TO: Mercedes-Benz Dealer Principals, General Managers, Sales Managers, Service Managers, Parts Managers	FROM: Gregory Gunther, Senior Manager, Vehicle Compliance and Analysis, Engineering Services
RE: Recall Campaign Launch Notification Inspect 12V and 48V Ground Connections MY22-23 C-Class (206 platform)	DATE: August 2, 2024

Campaign No. 2024070016, August 2024

SUBJECT: **Model C-Class (206 platform)**
Model Year 2022 – 2023

Inspect 12V and 48V Ground Connections

Figure 2

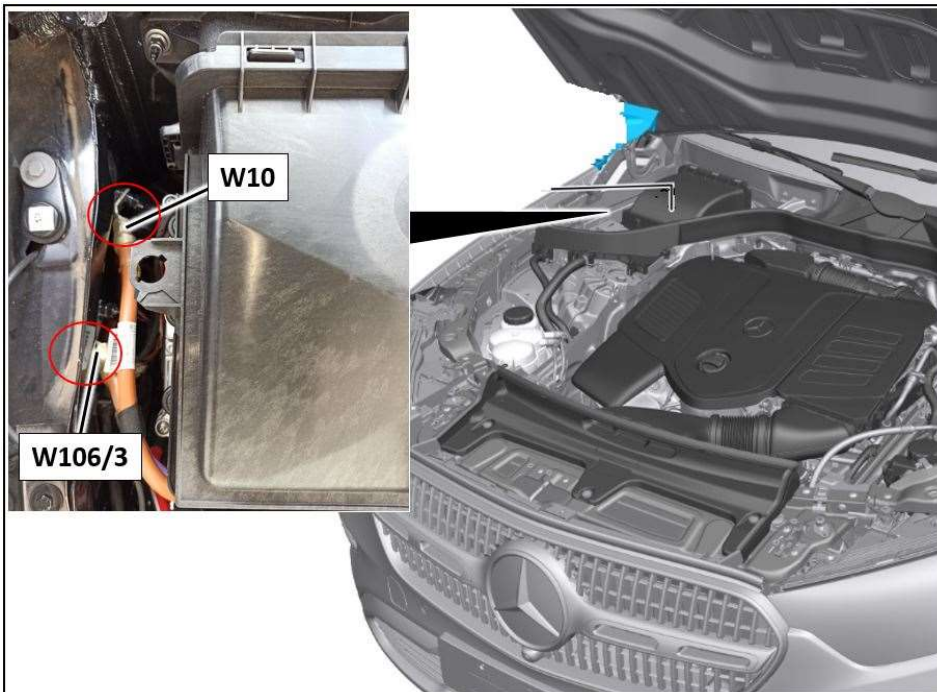
3. Check connections of ground points (Figure 2, W10 & W106/3) for correct tightening torque.

Nm 48 V battery ground point (W106/3) (see BA00.19-P-1039-01O) = **16 Nm**

Nm On-board electrical system battery ground point (W10) (see BA00.19-P-1012-01O) = **16 Nm**

- a. If torque is **Not Correct**: Carry out **Check/Test Procedure 2**.
- b. If torque is **Correct**: Carry out **Check/Test Procedure 3**.

Nm 48 V battery ground point (**W106/3**) (see BA00.19-P-1039-01O) = **16 Nm**

Nm On-board electrical system battery ground point (**W10**) (see BA00.19-P-1012-01O) = **16 Nm**

Figure 5, Examples of potential damage profiles of a 48 V battery ground point (W106/3)

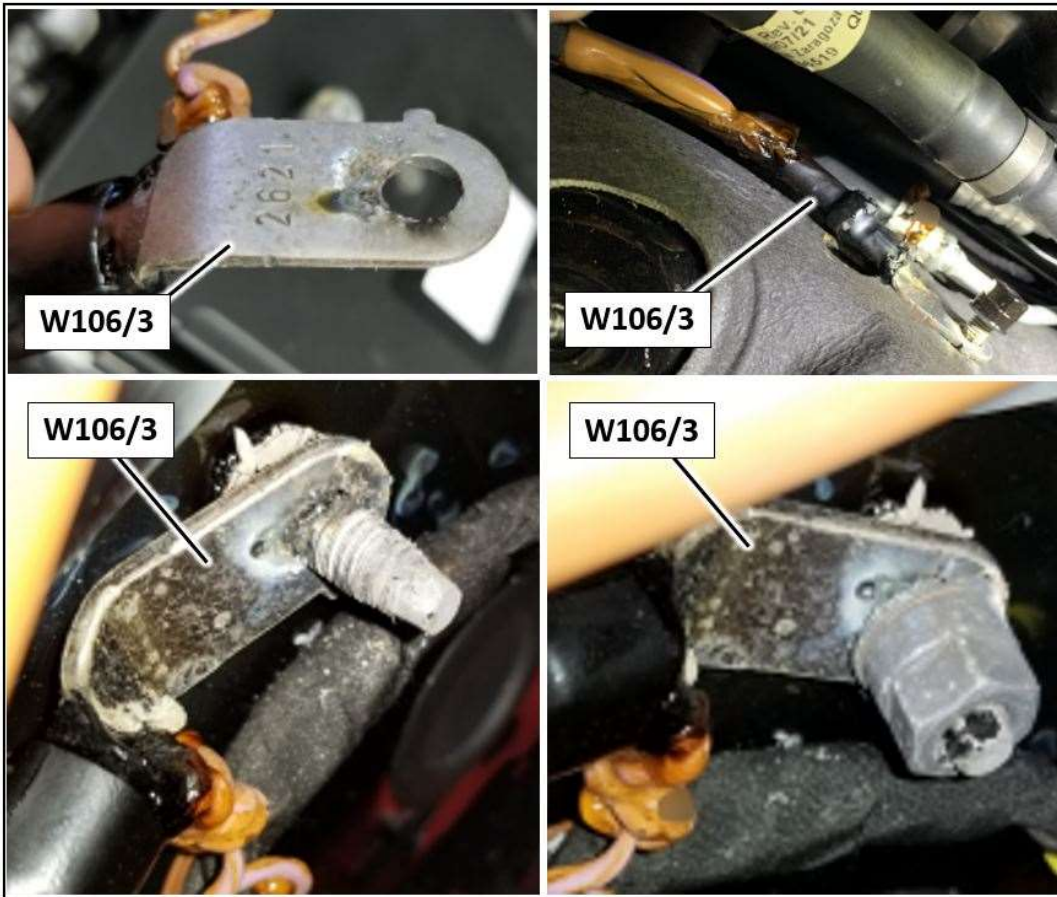
3. Remove respective affected cable lug from weld stud.
4. Check respective affected electric line, contact areas, and weld stud for **damage, such as arcing, scorch marks and/or melting**.

i See examples of the damage profiles (**Figures 5 and 6**).

- a. If there is **no** damage to the electric line, contact areas, or weld stud: **Carry out Work Procedure 1.**
- b. If one or both electric line(s), contact areas, or weld studs **are damaged**: **Carry out Work Procedure 2.**

Figure 7

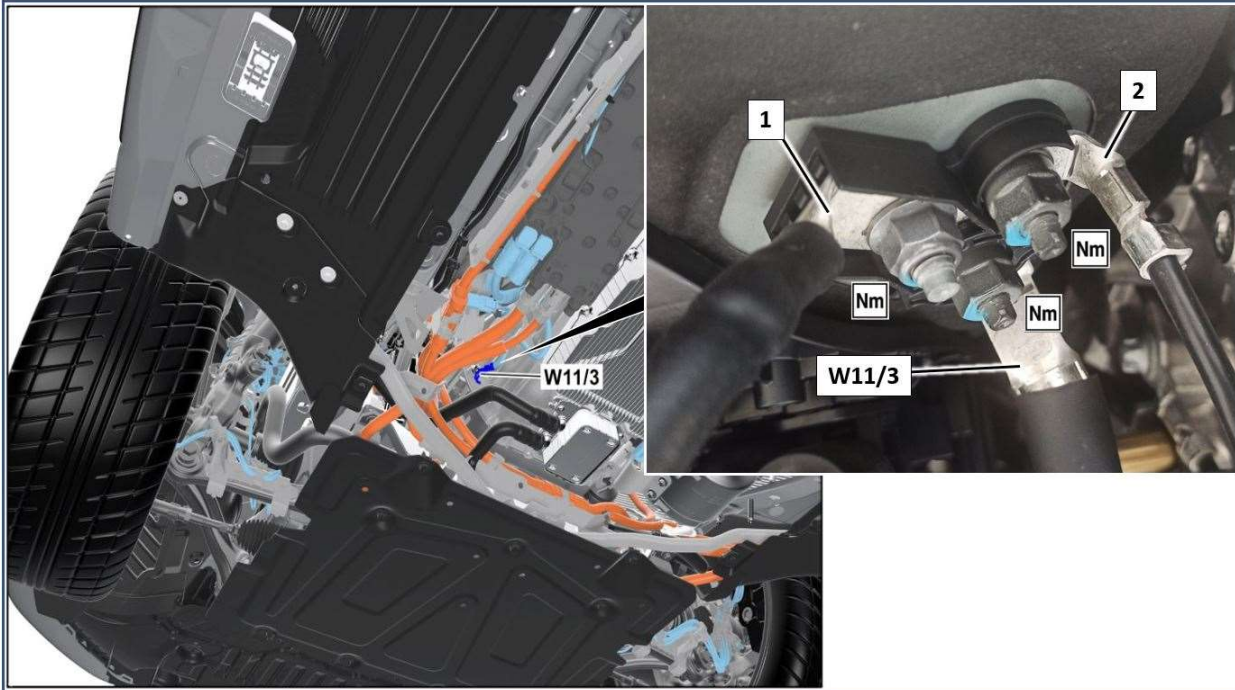
2. Check threaded connections at ground points (**Figure 7, 1, 2, & W11/3**) for correct tightening torque.

Left combustion engine ground point (**Figure 7, W11/3**) = 20 Nm

**Circuit 31 ground point with code B01 (Figure 7, 2) = 20 Nm**

**Circuit 41 ground point, with engine 654 and code B01 (Figure 7, 1) = 16 Nm**

- a. If the torque is **correct**: **End measure.**
- b. If the torque is **not** correct: Carry out **Check/Test Procedure 4.**

1. Replace respective nut at ground point (**Figure 7, W11/3, 1, or 2**) and tighten with specified tightening torque.

Nm Left combustion engine ground point (**Figure 7, W11/3**) = 20 Nm

Nm Circuit 31 ground point with code B01 (**Figure 7, 2**) = 20 Nm

Nm Circuit 41 ground point, with engine 654 and with code B01 (**Figure 7, 1**) = 16 Nm

Figure 8, example of potential ground point damage profiles (1, 2, W11/3)

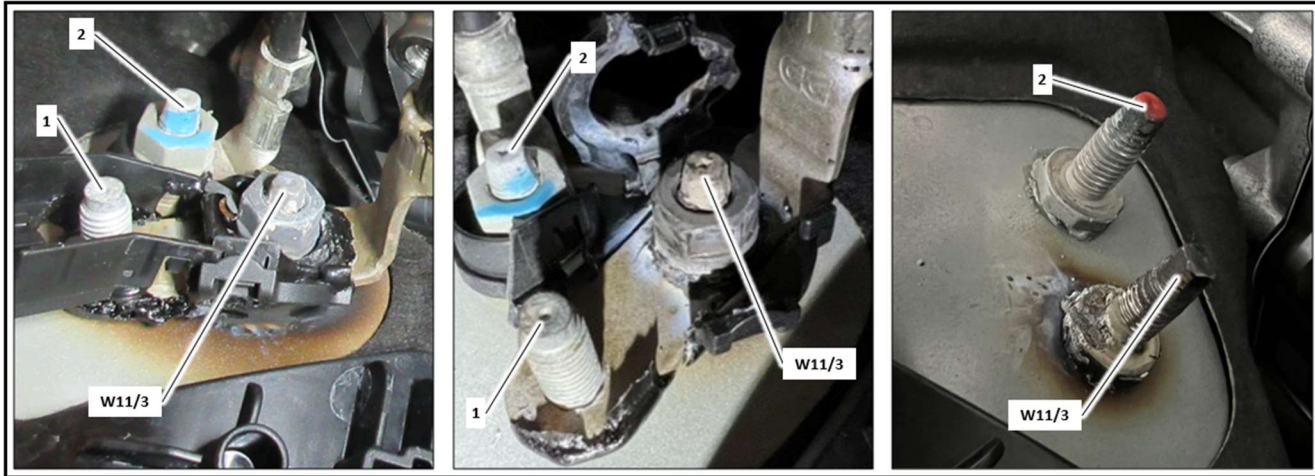
1. Remove respective affected nut from ground point (**Figure 7, W11/3, 1, or 2**) and perform a visual check of the affected electric line, contact area, and weld stud.

i See examples of damage profiles (**Figure 8**).

- a. If contact area, weld stud, and electric line are **not** damaged: Carry out **Work Procedure 3**.
- b. If contact area, weld stud, and/or electric line **are damaged**: Carry out **Work Procedure 4**.
